Hearing Examiner Meeting

Subject:
S2021-107 Goose Ridge Estates 2 Preliminary Plat

**CITY OF RICHLAND DEVELOPMENT SERVICES DIVISION
STAFF REPORT TO THE HEARING EXAMINER**

PROPOSAL NAME: Goose Ridge Estates II - Preliminary Plat

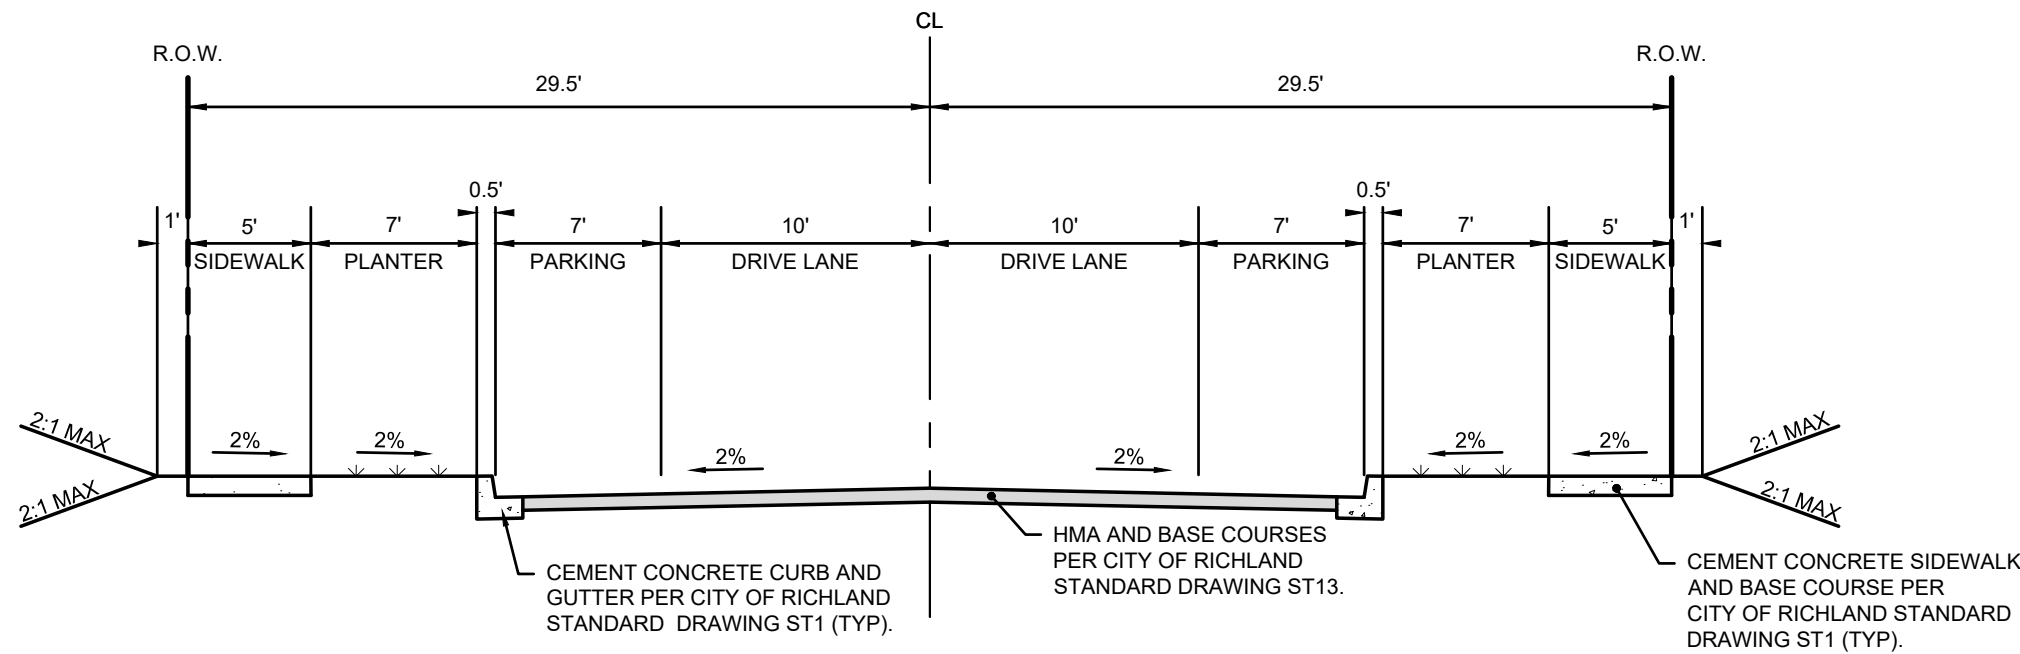
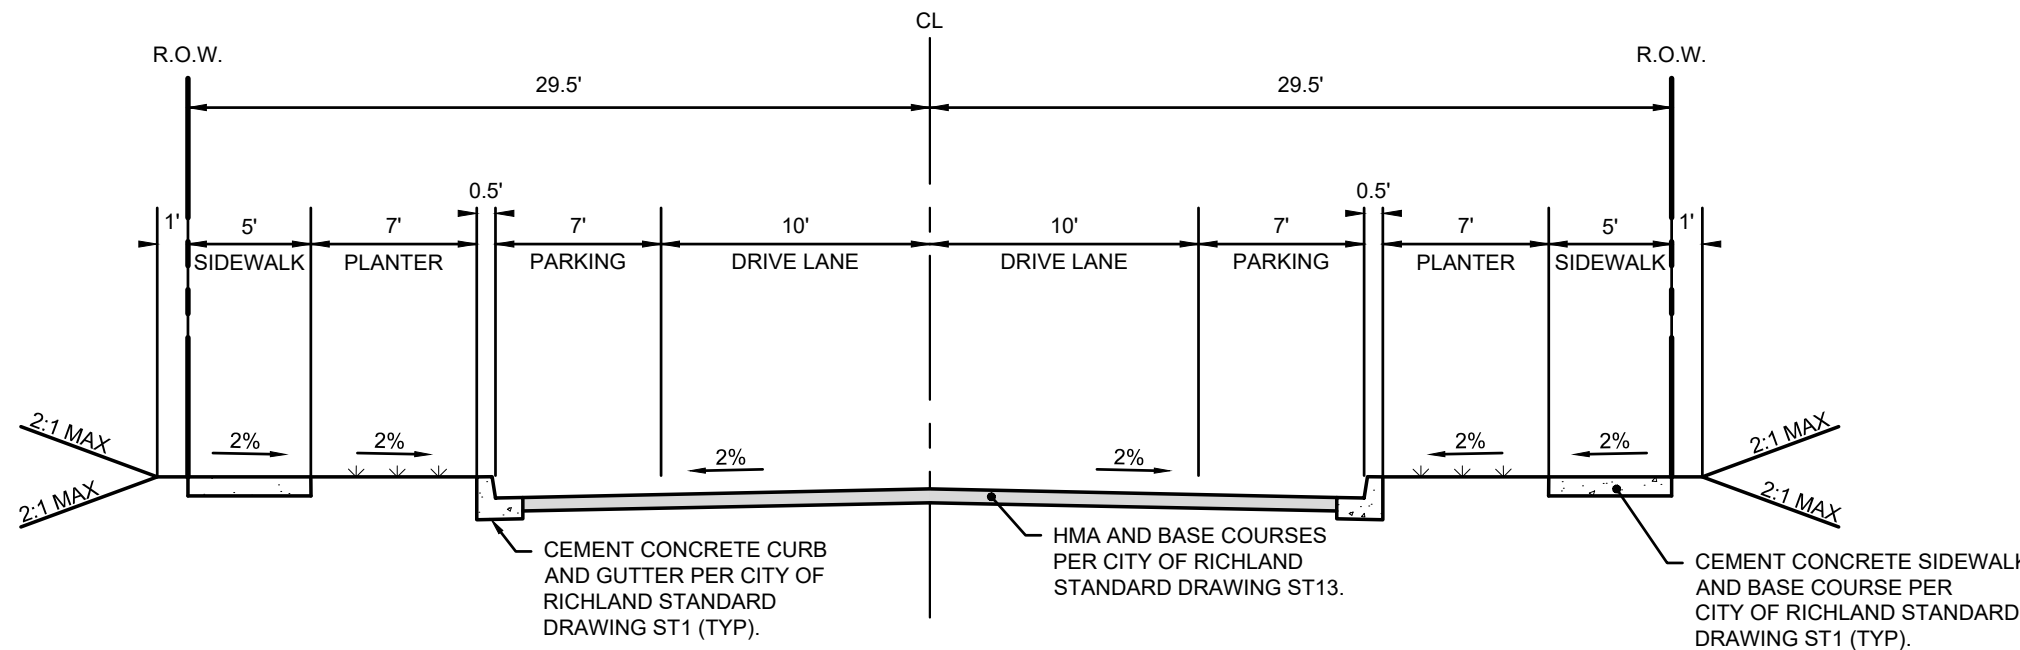
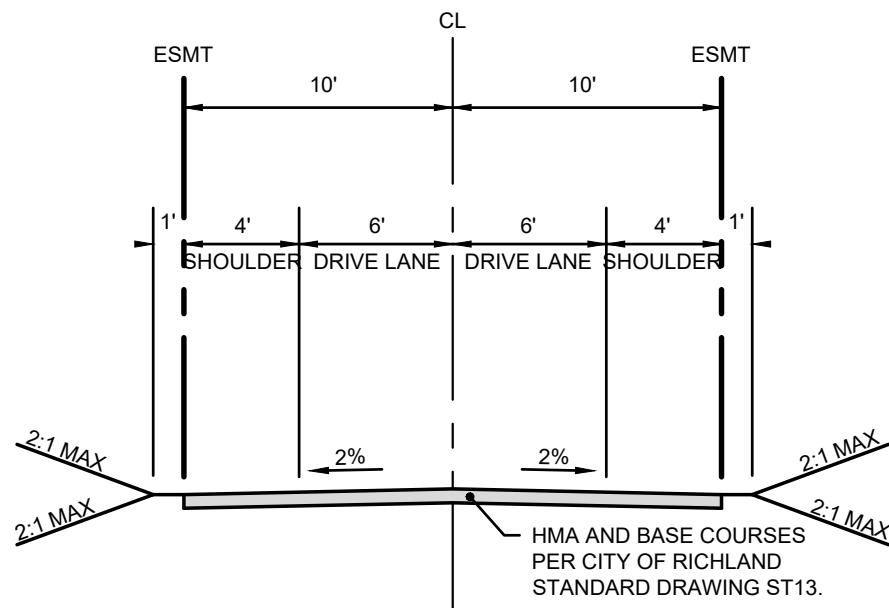
Note, on sheet C003 of the plat, the road cross-section details for minor collectors and local streets are identical. Sheet C101 correlates each road to cross-sections on Sheet C003 by way of numbered symbol. By way of condition, Public Works staff highlights right-of-way width inconsistencies between the proposed plat document, existing roads to the west and revised road profiles in the proposed LUDR amendment (Exhibit 6). It appears this discrepancy results from Goose Ridge Estates II excluding public walkways from the right-of-way. Recommended approval condition #63 aims to resolve this issue by requiring sidewalks and other edge type features to be included in rights-of-way.

Public Works review staff notes that the road profiles on Sheet C003 (Exhibit 2) do not match those shown in the proposed LUDR amendment submittal document (Exhibit 8). It appears that this discrepancy is the result of placing sidewalks in private tracts to be owned and managed by the HOA. Because this configuration is inconsistent with a vast majority of residential neighborhoods in Richland and in BMS, staff proposes a condition of approval requiring the rights-of-way be redesigned to include all public sidewalks and other features of required edge-types.

16. On Sheet C003 the ROW widths proposed for the different street sections do not match the ROW widths shown on the other sheets, or those in the adjacent plat ("Goose Ridge ph.2") or the LUDR. Please reconcile.

19. Corvina Street as designed on this proposed pre-plat will be classified as a "Minor Collector".
20. The City anticipates an update to the LUDR in the near future that will revise the standard street cross sections throughout Badger Mountain South. The developer is requested to consult with Public Works regarding the anticipated cross section changes and to utilize them in anticipation of the LUDR update being completed. Alternatively, this project shall utilize street cross section designs in the LUDR as it exists at the time of infrastructure permitting.

Sheet No.
C201
6 of 7 Sheets

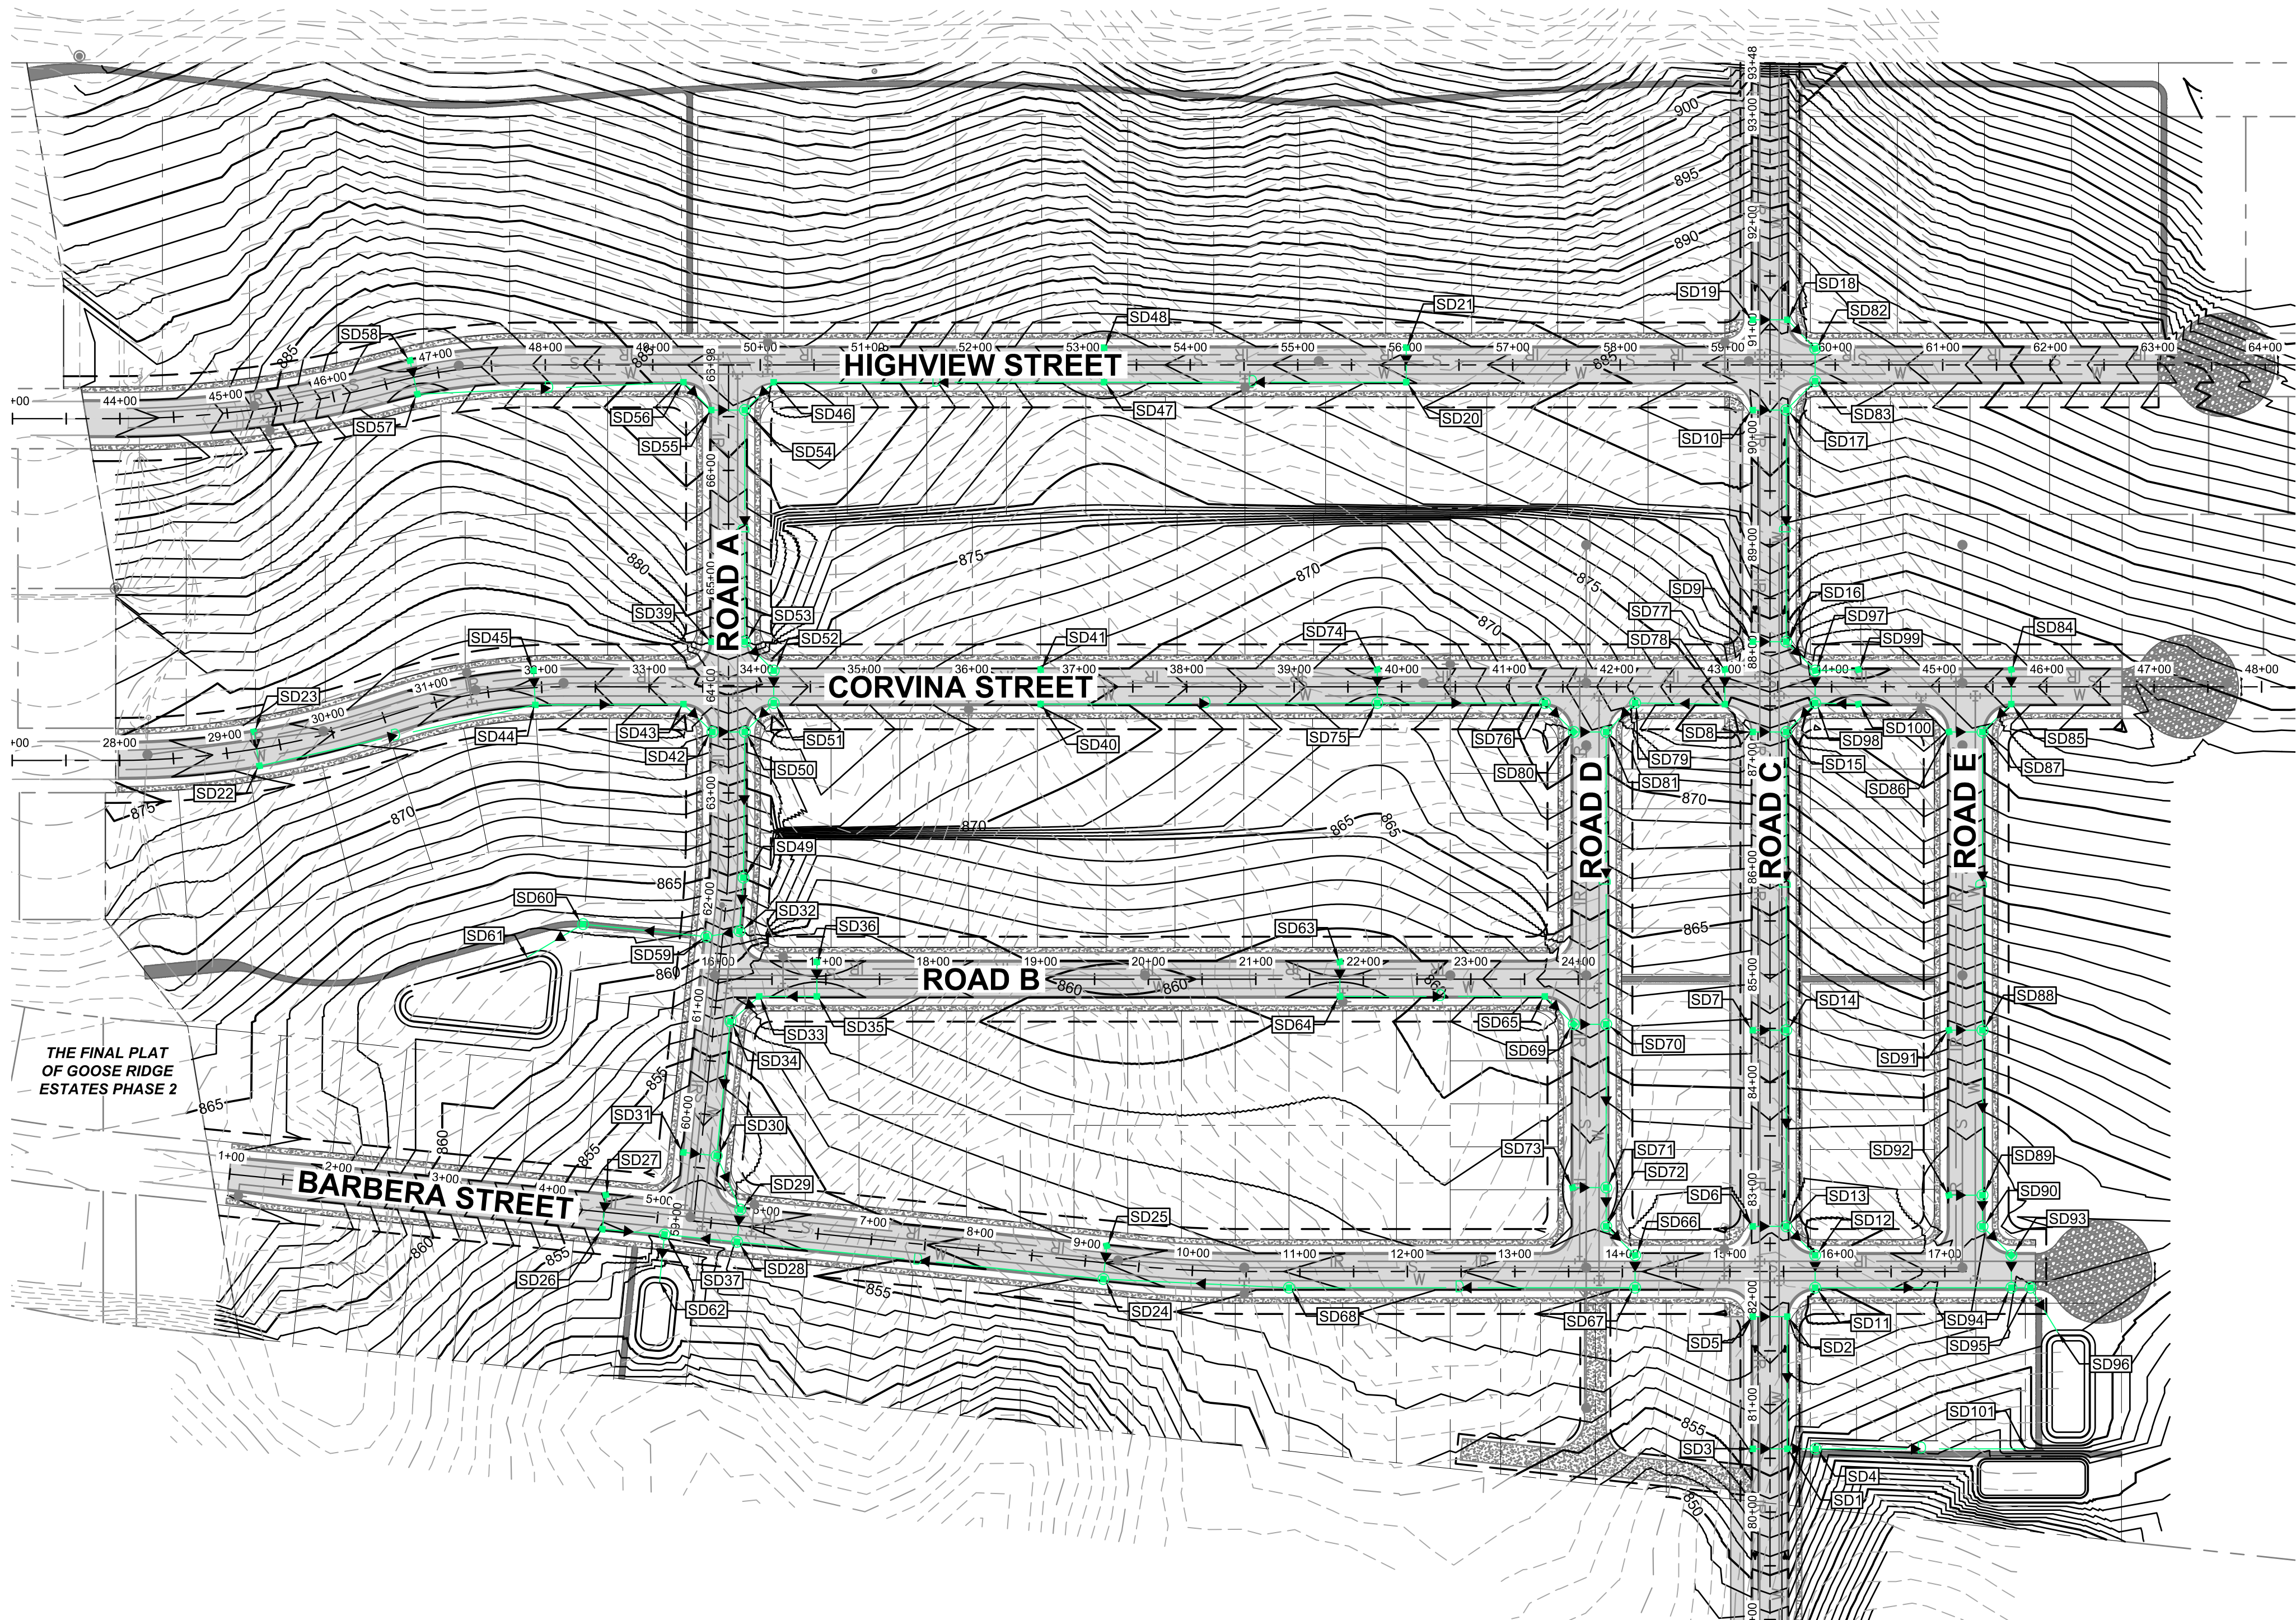
- The proposed plat includes provisions for open space through creation of green-space tracts totaling 5.71-acres.
- The plat includes a plan for grading and drainage (Exhibit 2, Sheet C201). The provisions of the planned action for Badger Mountain South require that Department of Ecology Stormwater Management Manual for Eastern Washington be used in the design of drainage plans.
